Product Change Notification

Date Issued :	September 28, 2022	PCN Number :	512666
Reason for Change :	Capacity change or tool replacement		
Description of Change :	This notice is to inform you that Molex Lincoln Nebraska is adding replacement tooling that will affect the product listed. New tooling will be exact replica of current tooling. There will be no change to the product Fit, Form, Function or Appearance when compared to current tooling. Current tooling will be taken out of service once new tooling is qualified.		
Reason for Short Notice :	Corrective Actions		
Assessment of Change :	First Article Inspection		
Planned Implementation Date :	January 20, 2023		
Sample Availability Date:	October 21, 2022		
Internal Molex Qualification Date :	January 06, 2023		
Last date to request Samples by Customer :	December 09, 2022		
Traceability Code Markings / Date :	Product made after planned implementation date can contain the change

— Mini-Fit Vertical Header

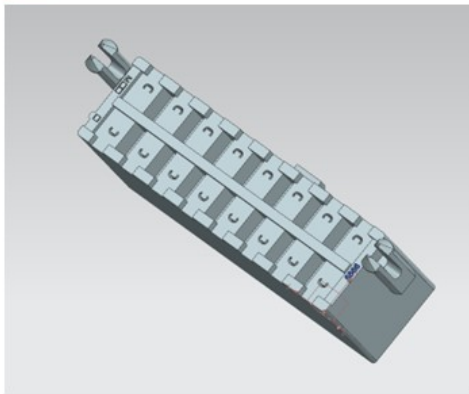
- To ensure exceptional quality, Molex Lincoln Nebraska is going to replace the tooling which produces the affected part numbers
 - New tooling will be an exact replica of current tooling
 - Tooling being added to keep up with current and future demand
- There is NO impact to Fit, Form or Function
- Samples available upon request after date shown above
- Part Numbers Impacted
 - See attached list
